ADA Curb Ramp New Construction Inspection Form (Perpendicular)

NW 313th Ave

24952.54

NW North Ave

PERPENDICULAR RAMP (PR)

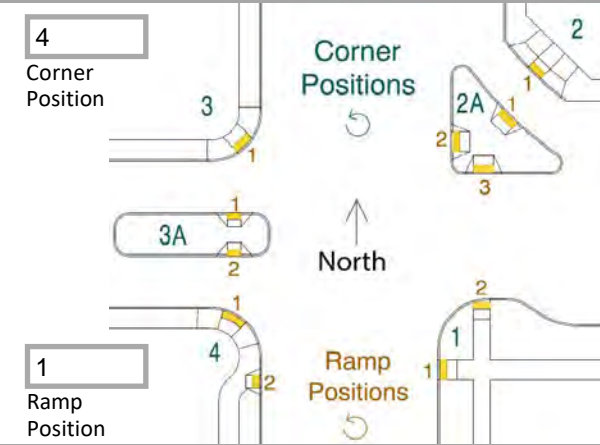
Slope X

2.2

>2.0%

☒

Slope Y

>2.0%

☒
